Staff Report

Meeting Date: October 12, 2023 (Prepared October 5, 2023)

Item: DR 23-03, PLA 23-03, SA 23-02, & VAR 23-05 "Commerce Way Industrial Park" at 1414 Commerce Way

Figure 3.01F – Local Industrial Street

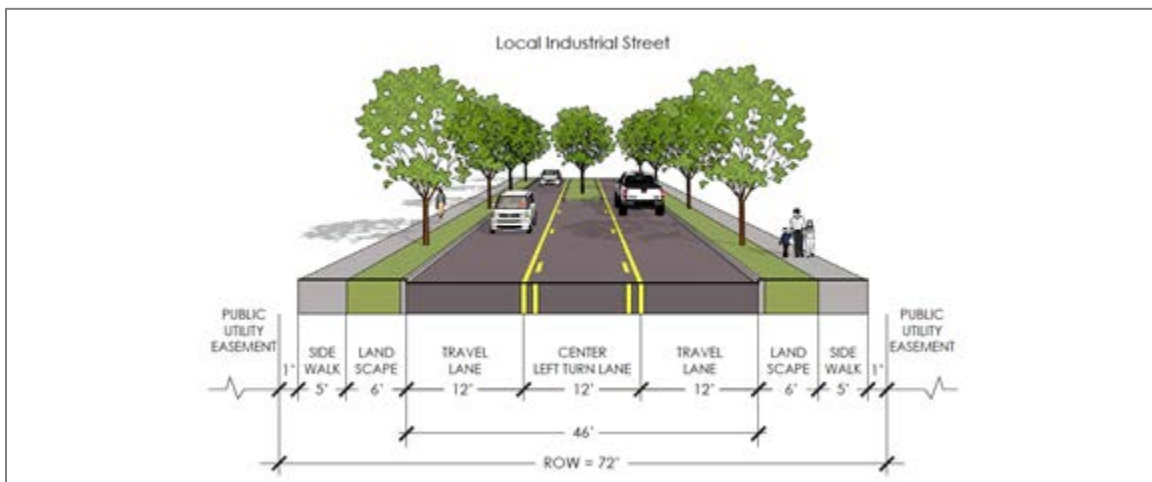
As noted in the analysis of 3.01, the applicant submitted a Street Adjustment application with a request to modify the applicable street cross-section for Commerce Way. Because every property that fronts Commerce Way is zoned Light Industrial (IL), the default cross-section is the Local Industrial cross-section (Figure 3.01F).

- Variable width of right-of-way (40 feet along Tax Lot 100, 60 feet along Tax Lot 5000), which does not meet the minimum width of 72 feet in the cross-section;
- No paved travel lanes or center turn lane, only a gravel road between 10-12 feet wide;
- No curb or drainage facilities;
- No landscape strip with street trees; and
- No sidewalk.

STREET EXCEPTION REQUEST FOR COMMERCE WAY TYPICAL SECTION
SCALE: 1" = 5'

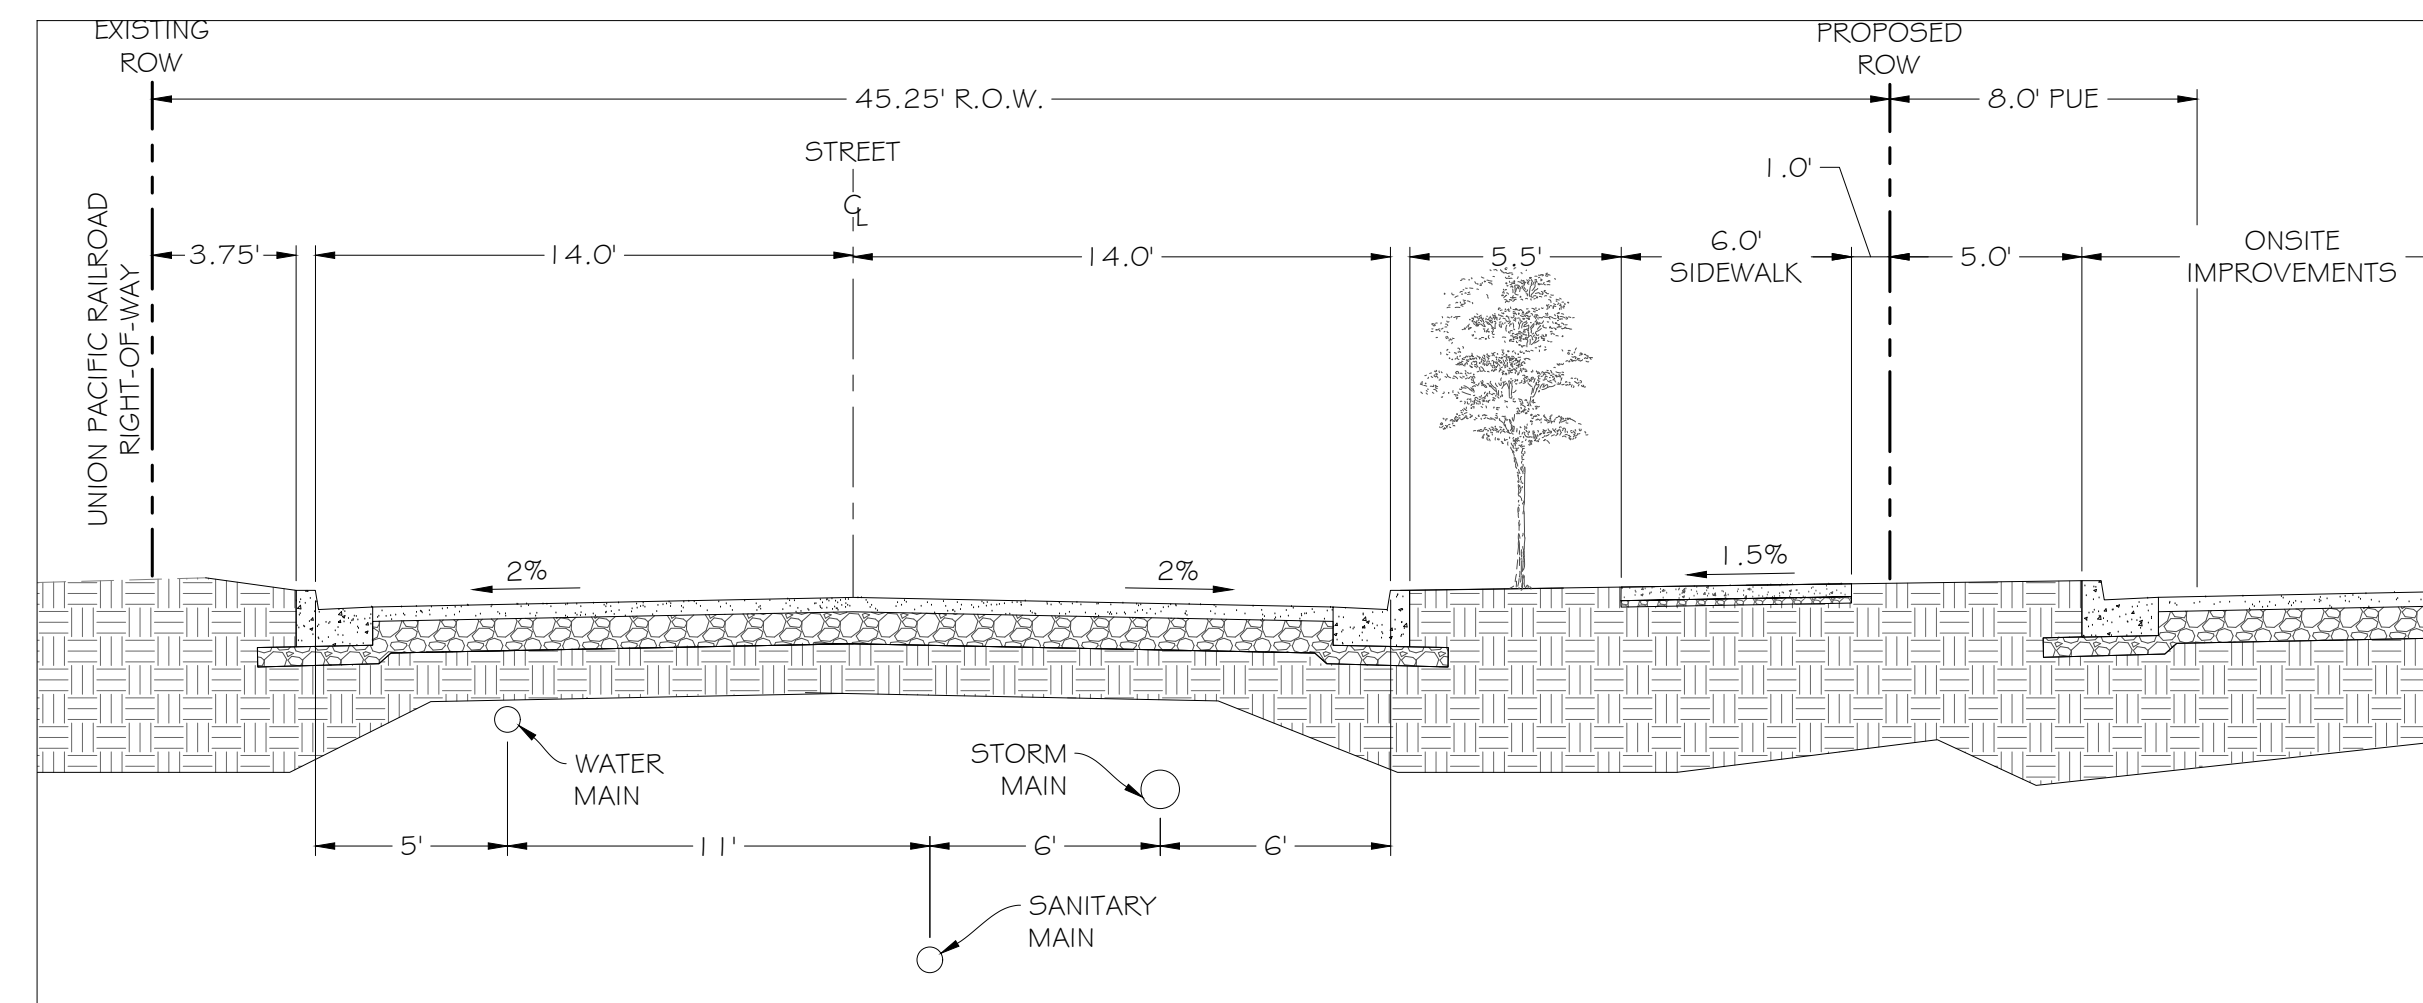
11. Commerce Way improvements: In conformance with the proposed street cross-section illustrated on Sheet C-0.03, the developer shall complete the following right-of-way (ROW) improvements to Commerce Way along the frontage of the subject properties:

- a. Improvements: Construct street improvements to match the cross-section on Sheet C-0.03 and the site plan on Sheet C-1.07. Improvements are due prior to building permit issuance.

C-1.01

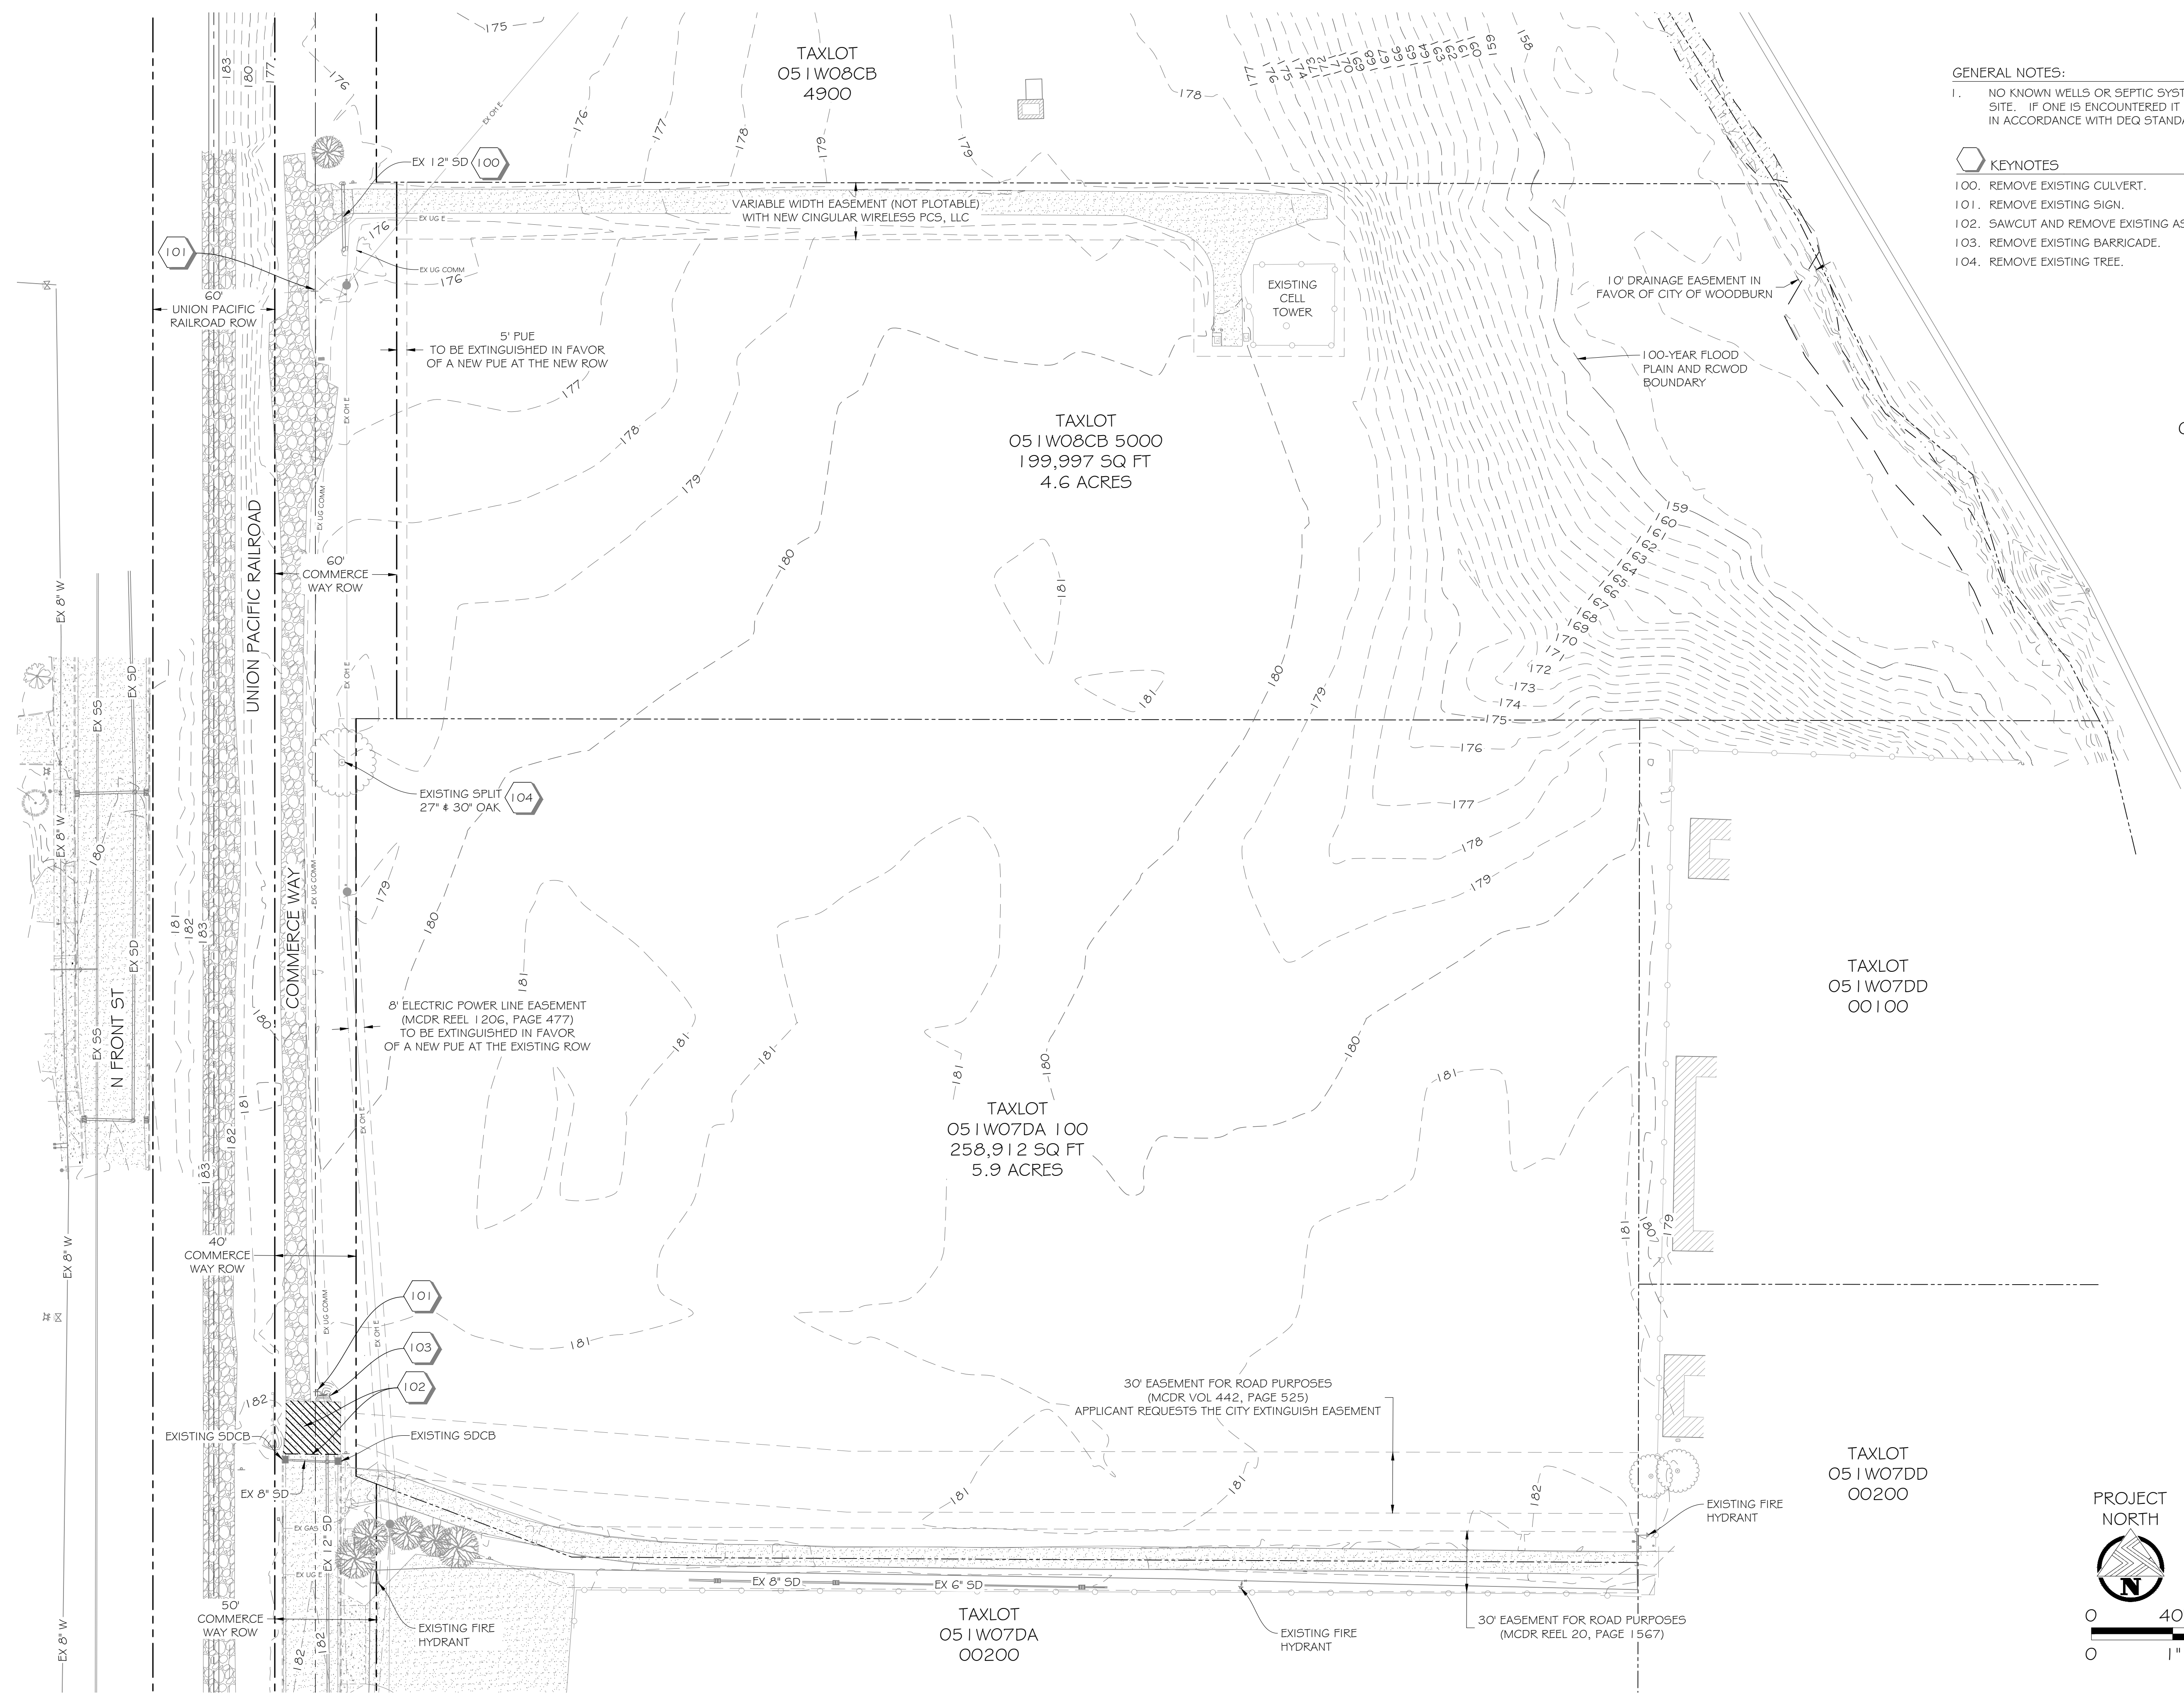
There are no significant trees on private property. The existing split 27-inch and 30-inch Oak tree illustrated on Sheet C-1.01 is within the right-of-way.
